PRELIMINARY OVERALL  
AREA DEVELOPMENT PLAN  
POADP # 64

INFORMATION SHEET FOR  
PRELIMINARY OVERALL AREA DEVELOPMENT PLAN  
(P.O.A.D.P.)

Re: Crownridge ☐ Preliminary Plan  
File #: 83-12-64-08 ☒ P.O.A.D.P. (Revision dated  
June 26, 1984)

RE: Revised Crownridge Subdivision POADP #64

**CROWNIDGE OF TEXAS**  
**REVISED ROADP**  
**RECEIVED**

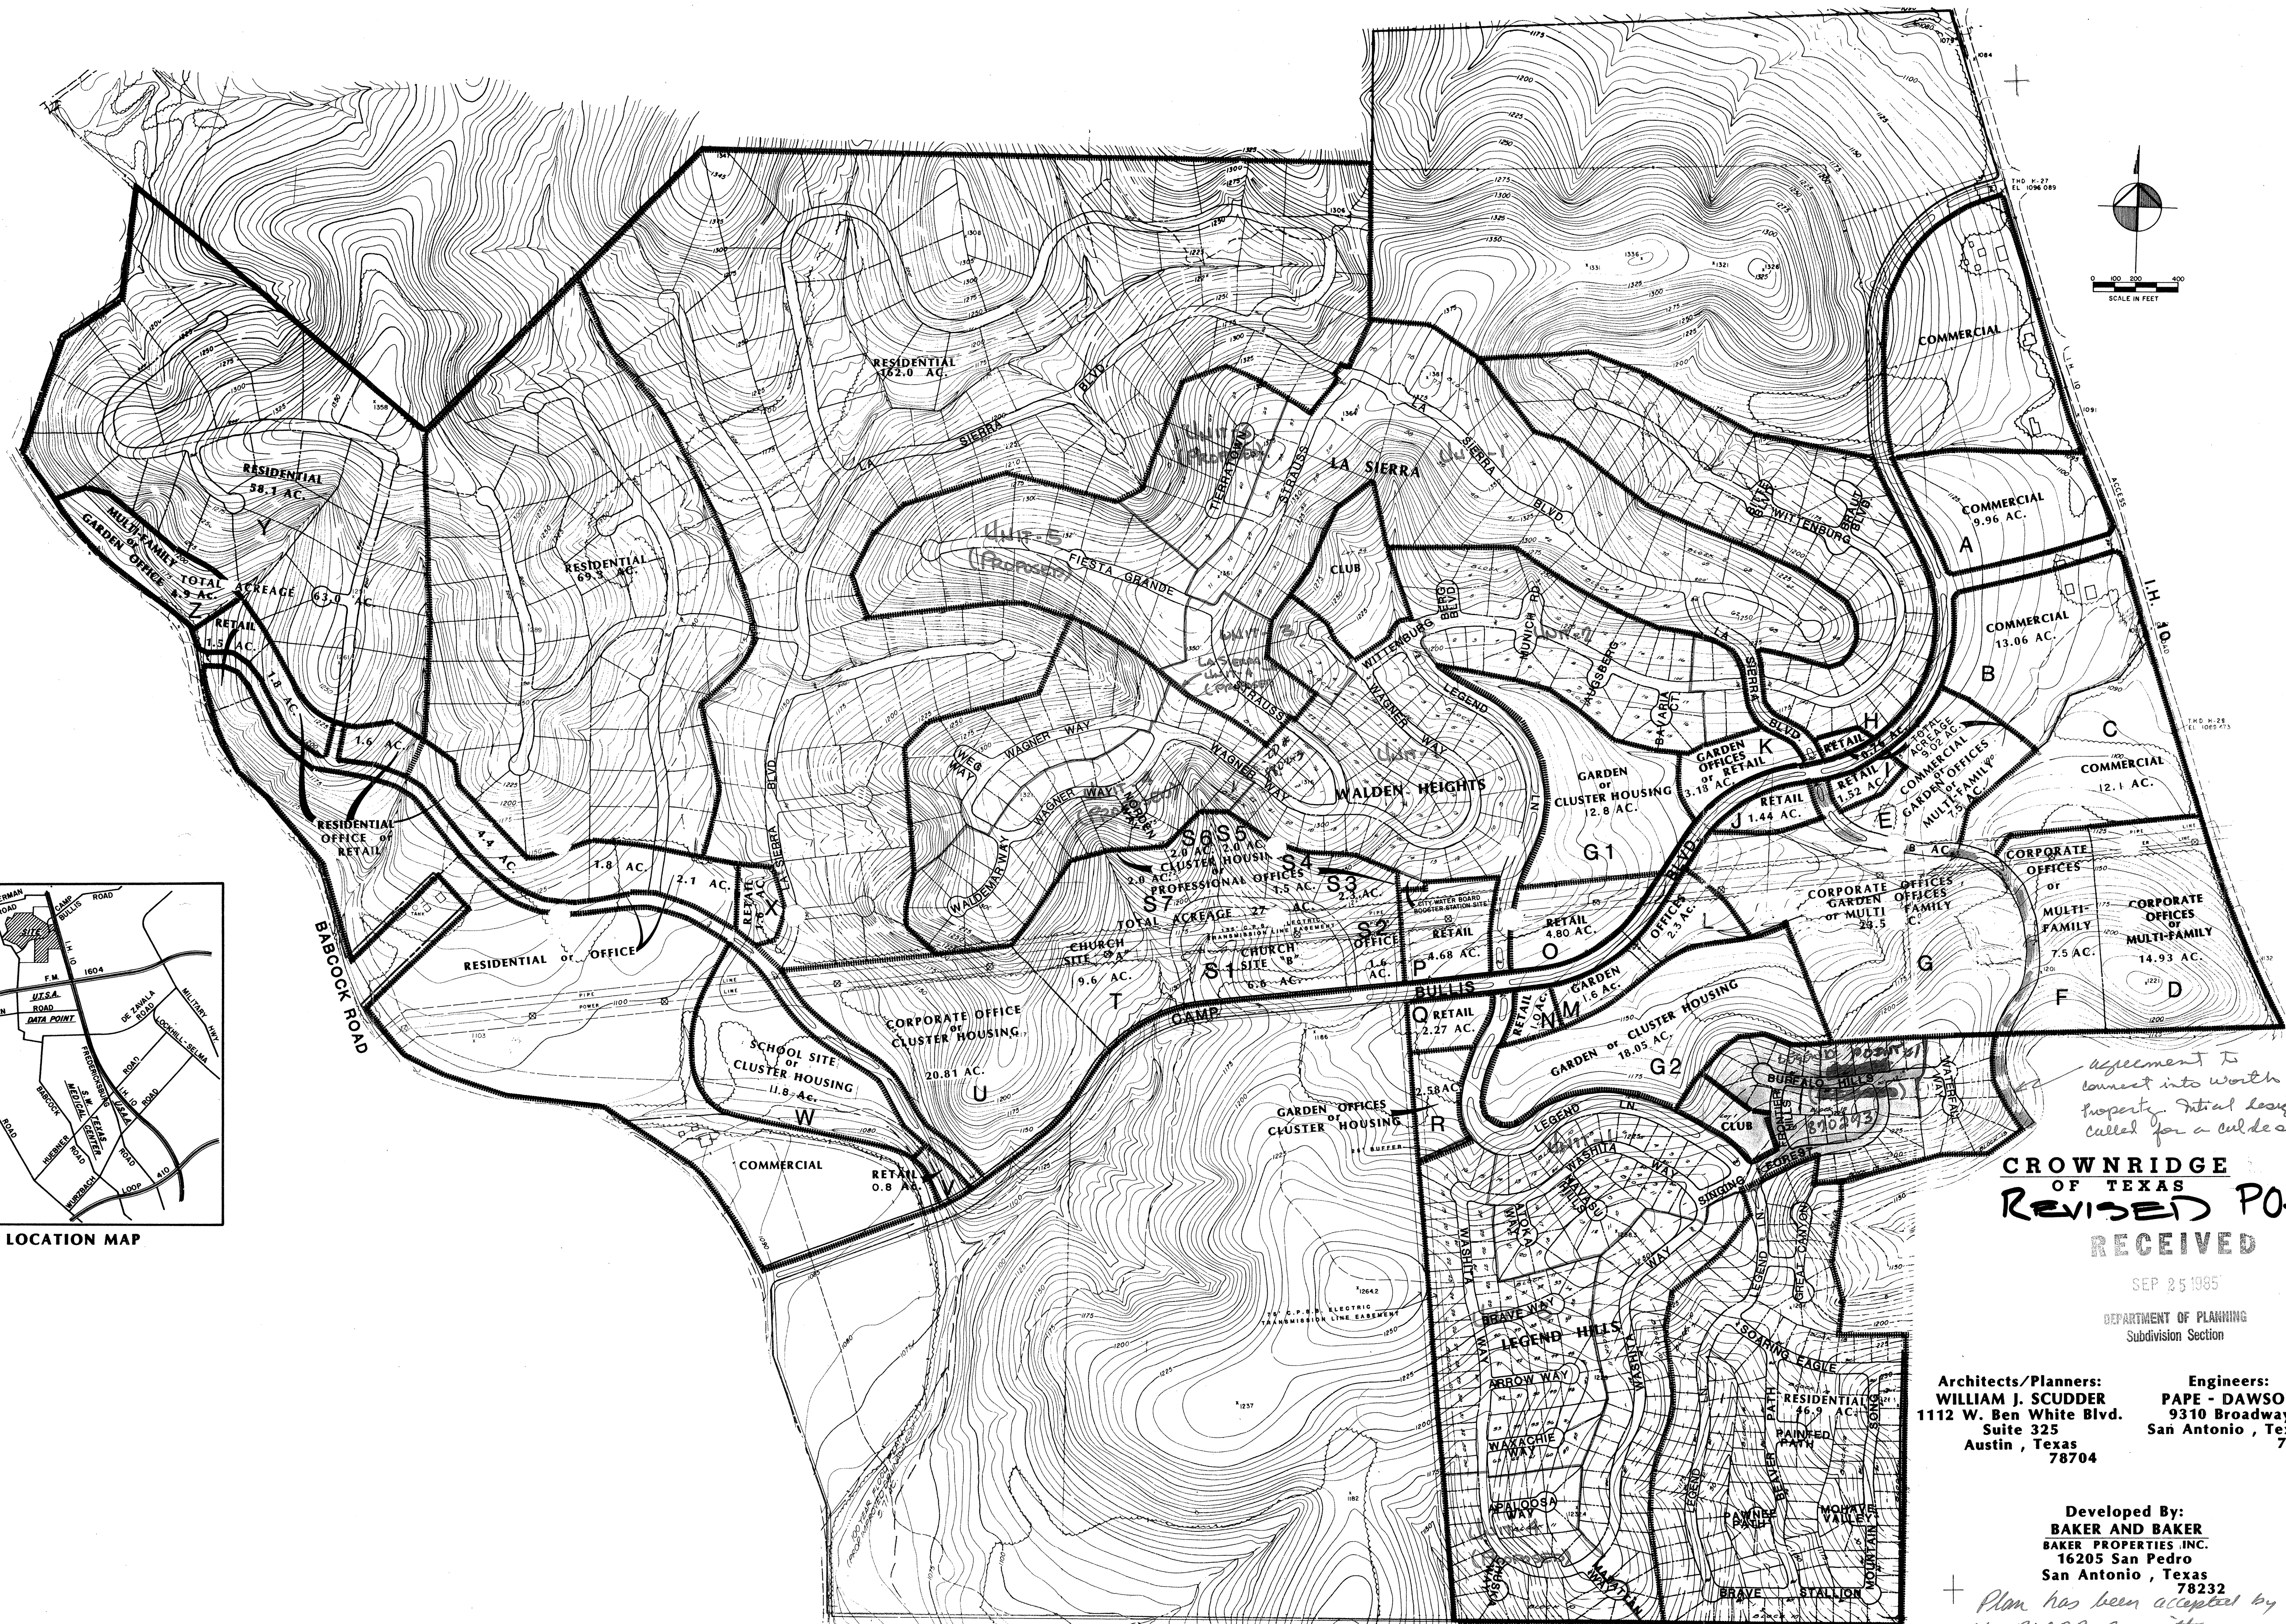
agreement to connect into worth property. Initial design called for a cul-de-sac.

Plan has been accepted by  
the ROADP Committee  
date Sept. 27, 1985  
Signed By Commissioner #64

LOST VILLAGES

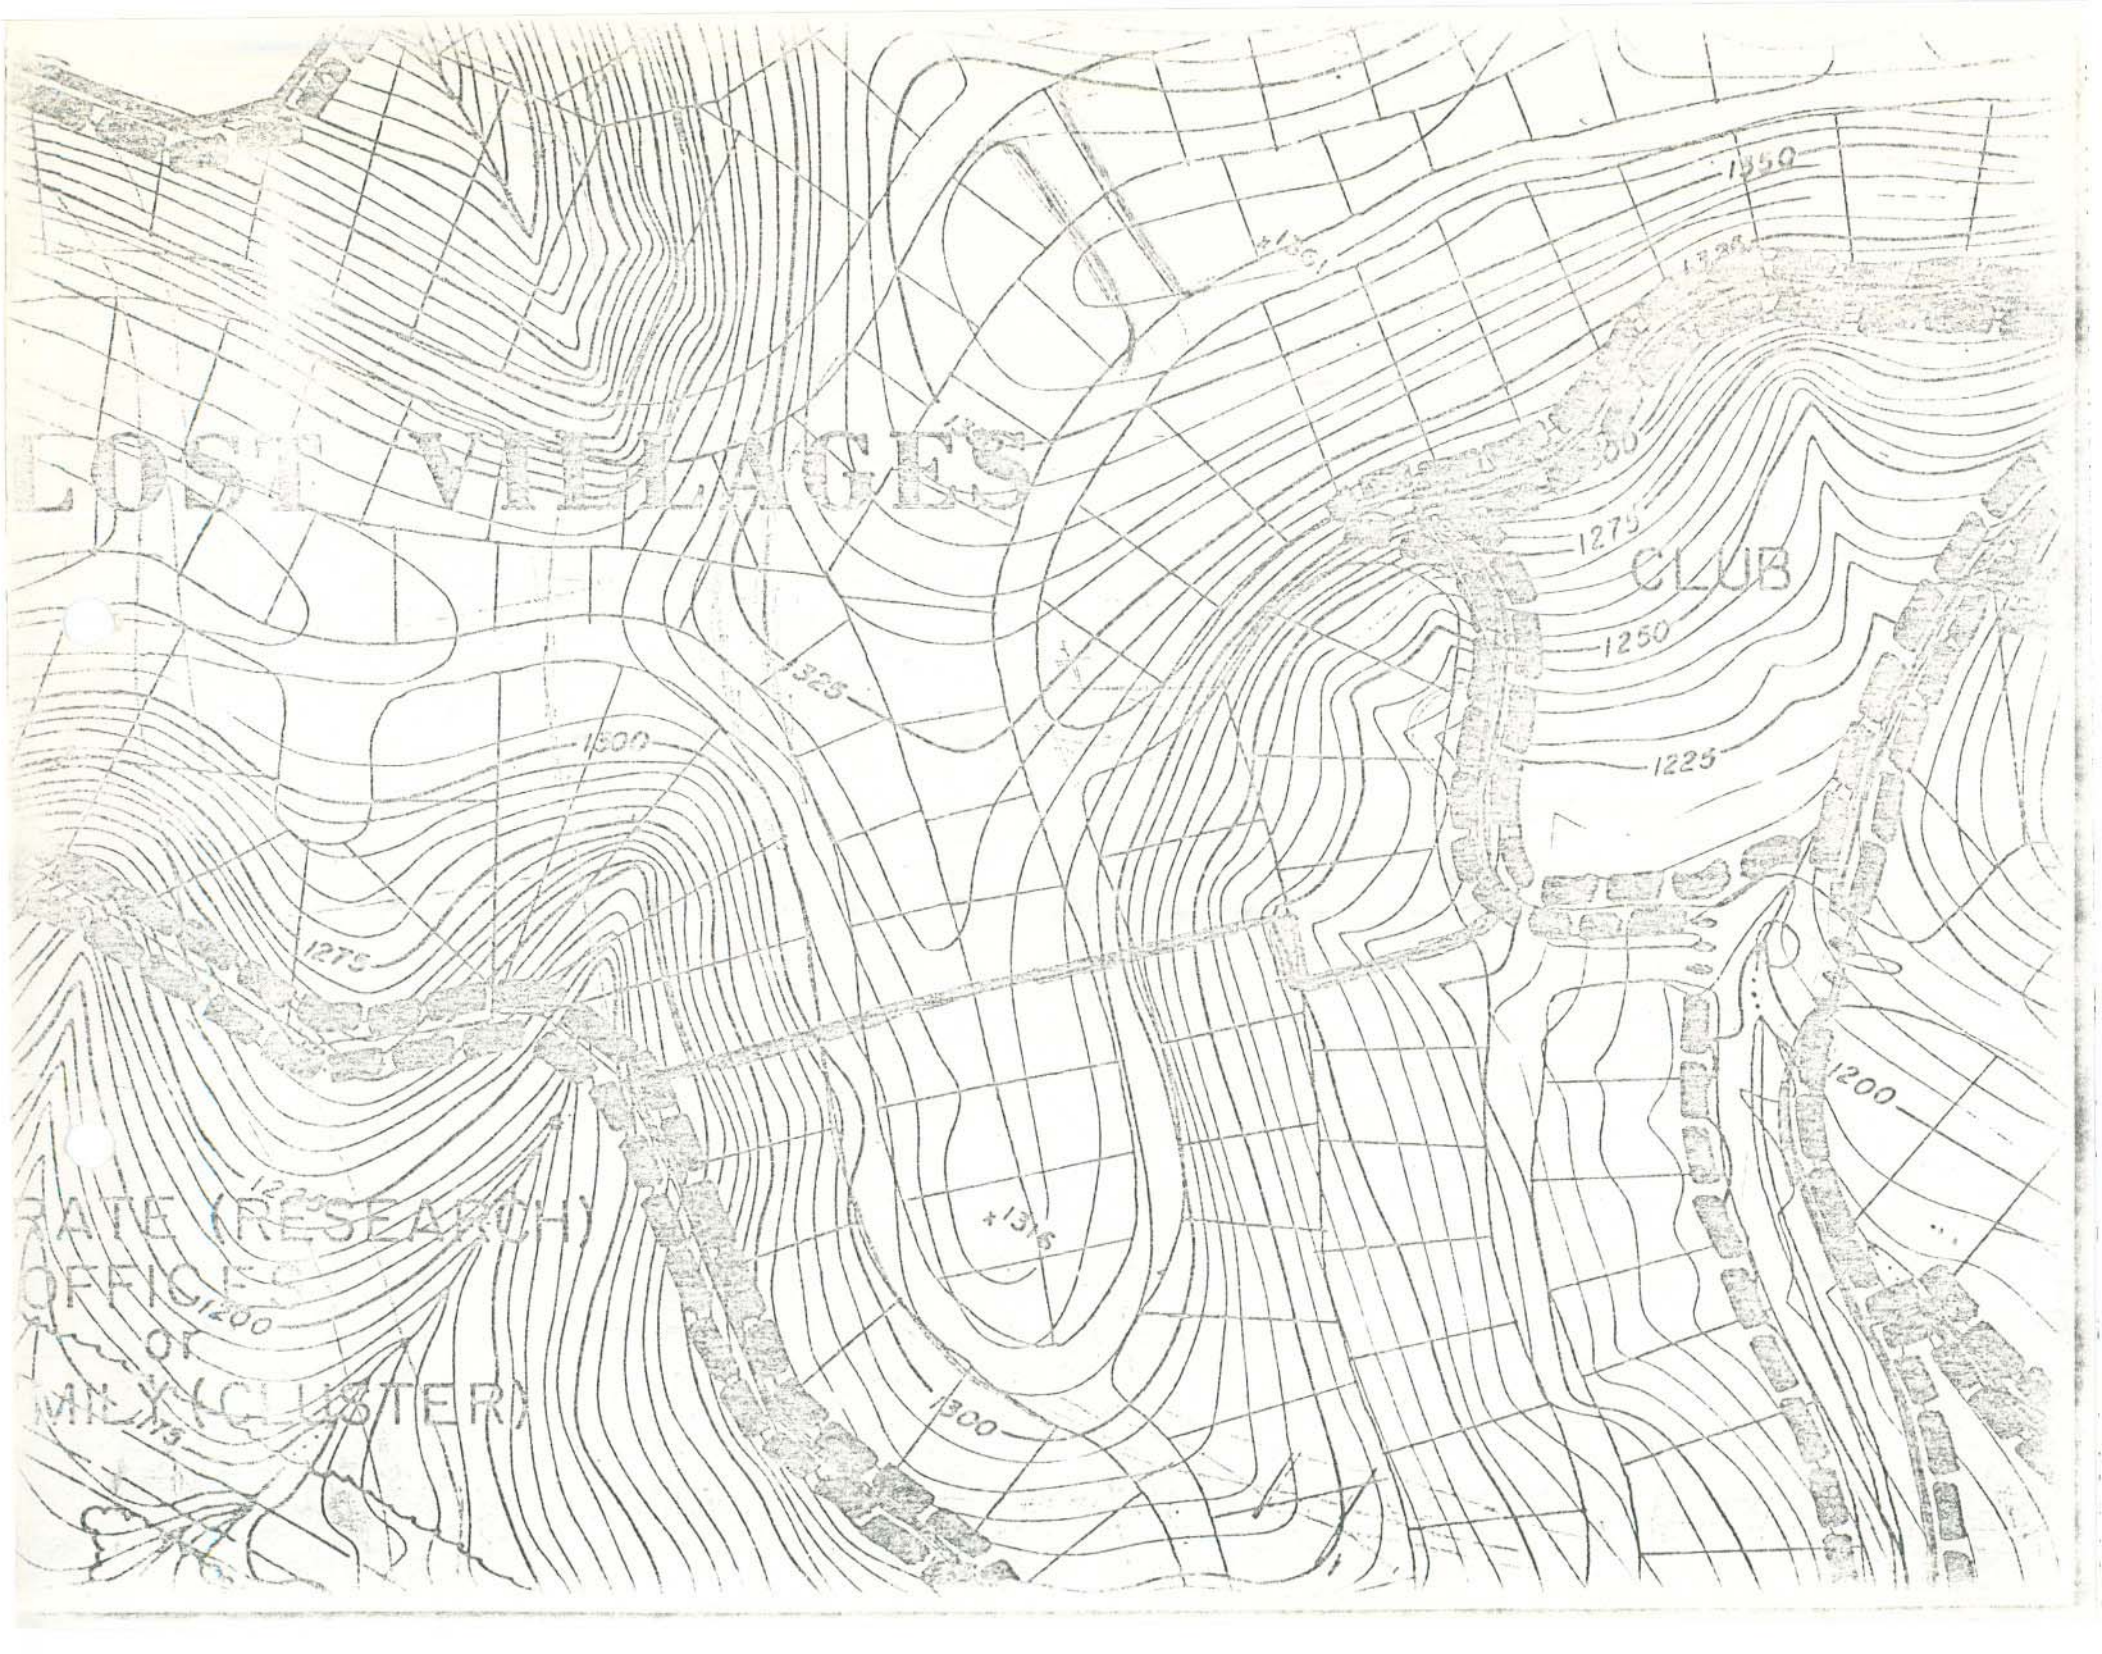
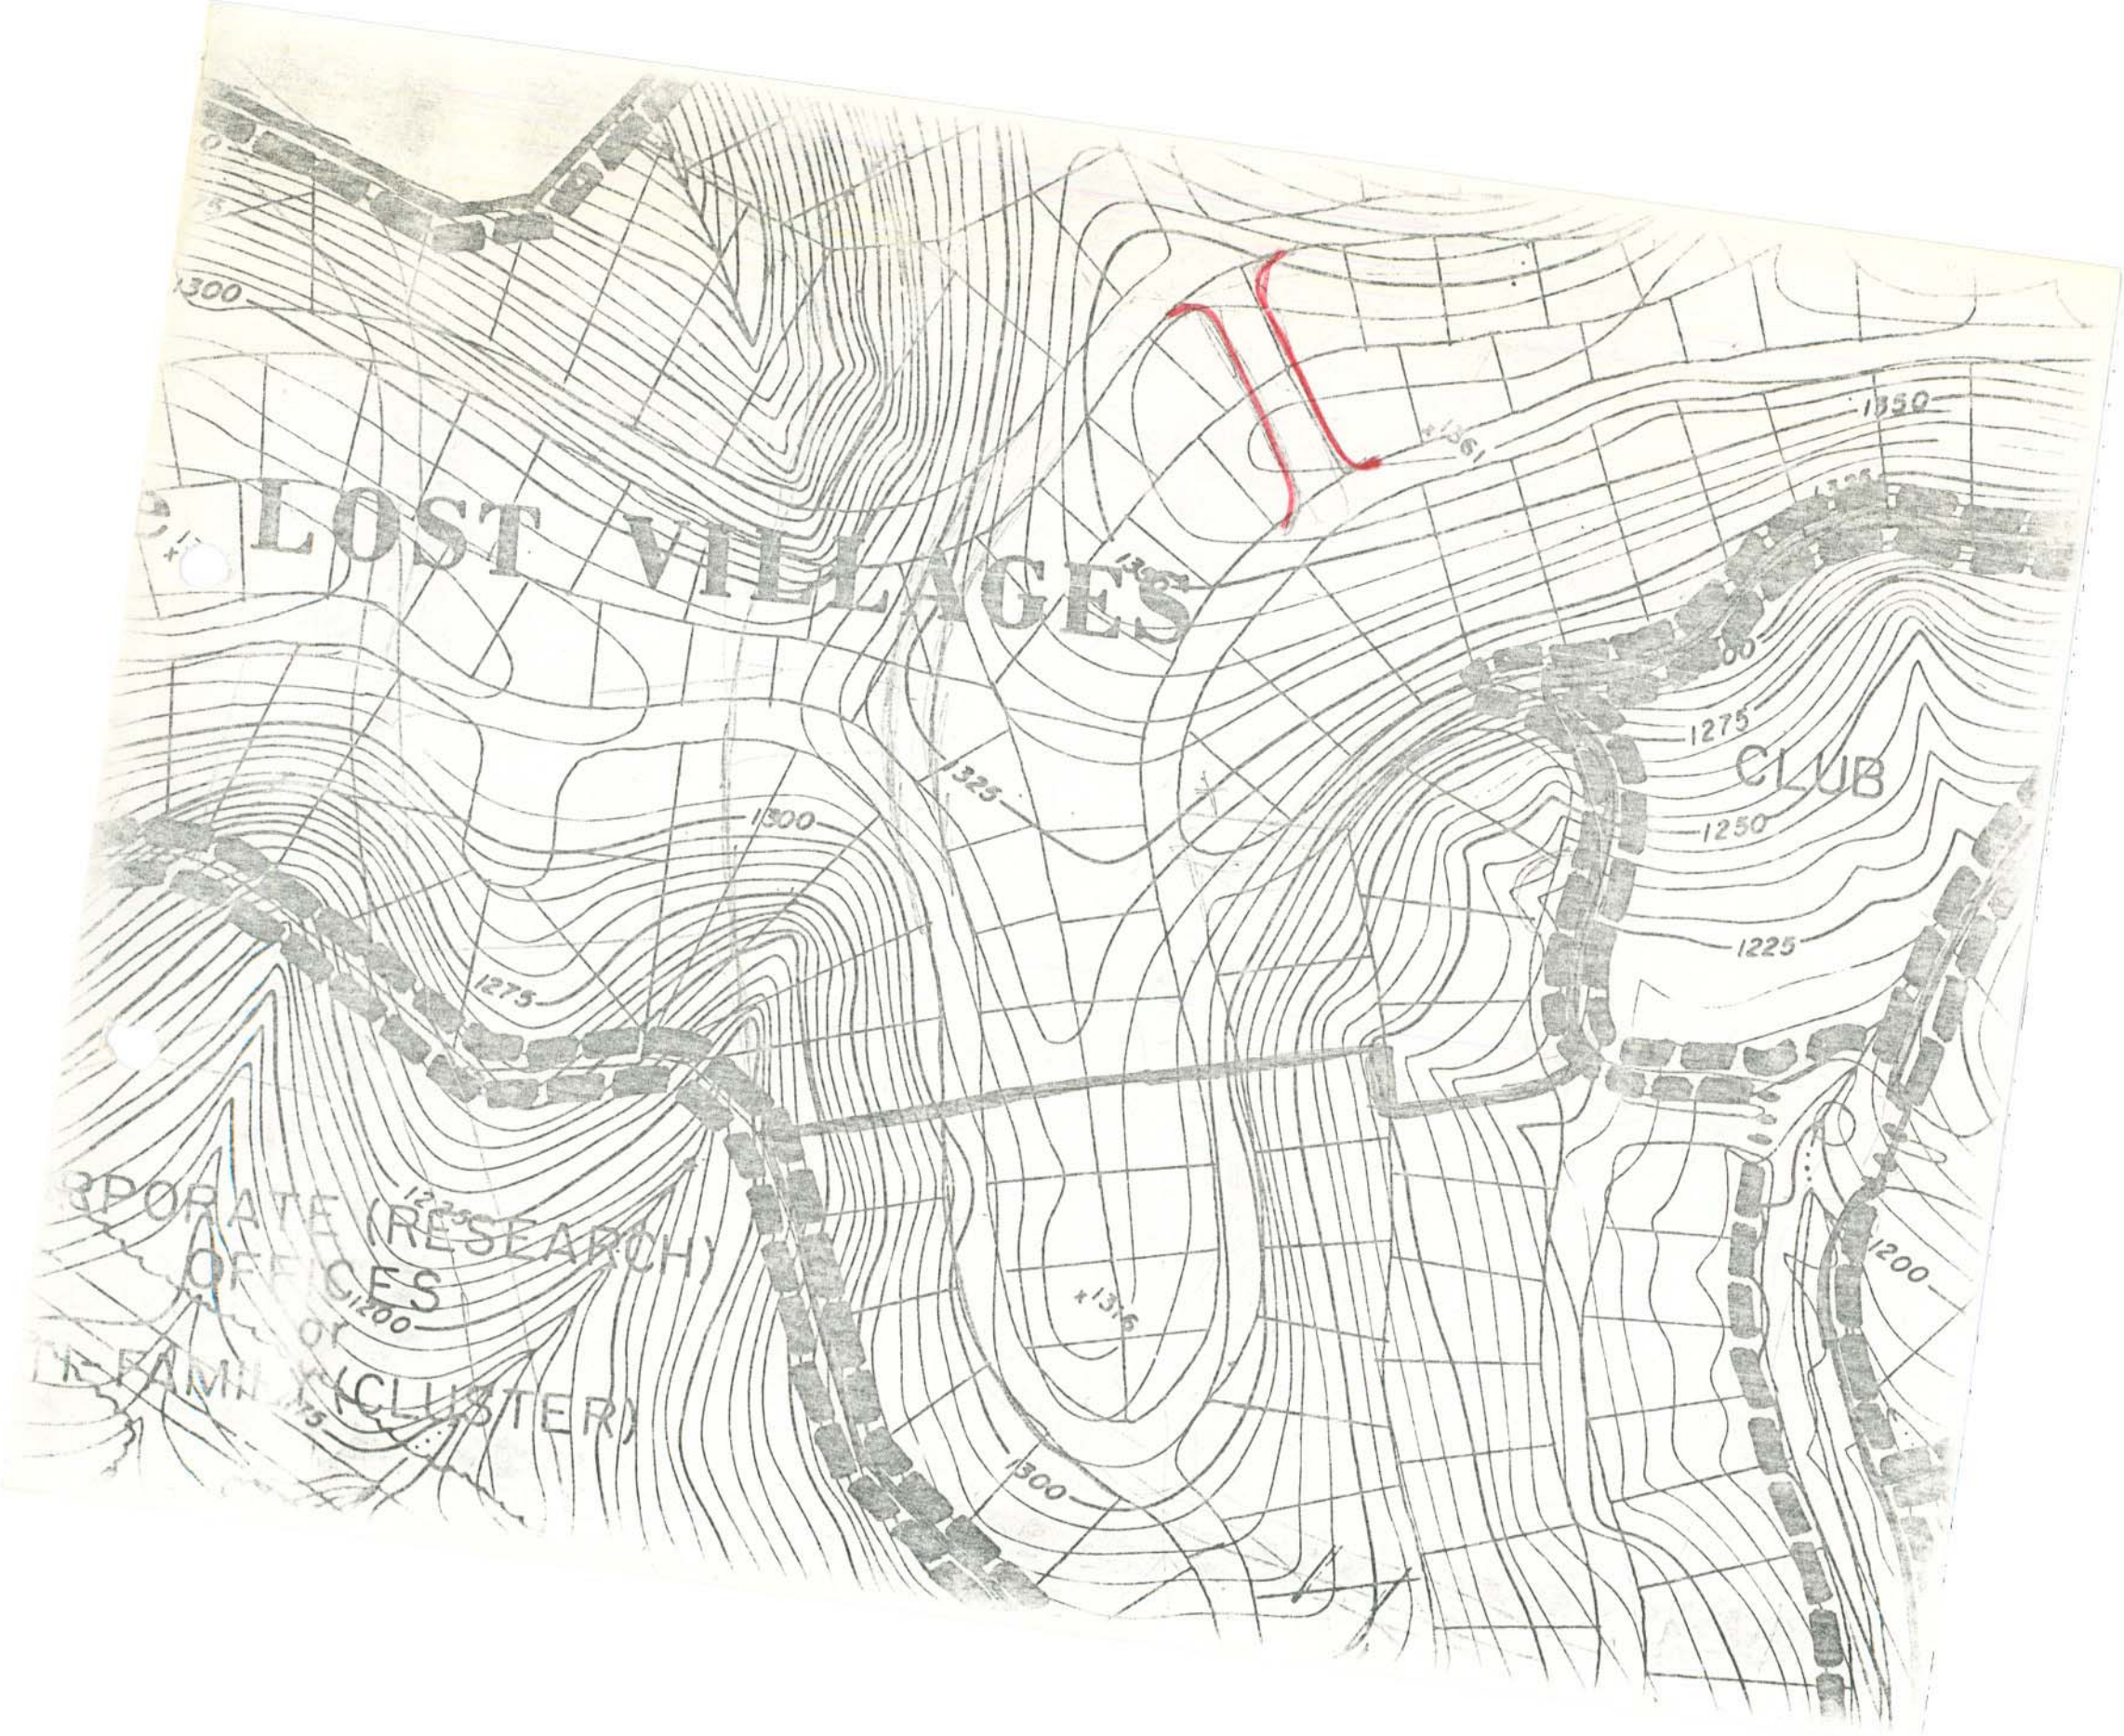
This is to confirm our discussions on the POADP for The Villages of Crownridge. With one exception we concur with the proposed layout of the first four units which you indicated have already been engineered and for which plats are practically complete.

The one exception that we have discussed is the efforts you will undertake to "flatten-out" the sharp curve on the entry street into the Hidden Hills unit, south of Crown Meadow Drive. In addition, we concur with the removal of all street stub-outs with the exception of the stub-out leading northeast from The Lost Villages unit pursuant to the agreement that you have with the property owner to the northeast of your POADP. Regarding the street stub-out from the Glen Villages unit, east toward Crown Meadow Drive, you have considered moving it northward approximately 550 feet. We recommend that said stub-out not be provided at either location since it would create heavy demands on a local residential street through the Glen Villages -- a function which should rest with the 86' entry street off of Crown Meadow which leads into the "club" area. Relative to the Lost Villages unit, we recommend a street connection as generally reflected on the attached exhibit to lessen the travel distance between the northwestern area of this development and the 86' entry street. This recommendation should fit in with the proposed street realignment in the immediate vicinity which we understand you are in the process of costing out.

☒ Comments: we have some concerns with the proposed street layout. Suggested alternatives: 1) Improve street layout; 2) Excise for stub out west from the Hidden Hills, remove all of the stubouts to prevent additional entry and contain traffic circulation within The Villages; 3) Take PUD approach for a more imaginative design layout (e.g. cluster housing, etc.).
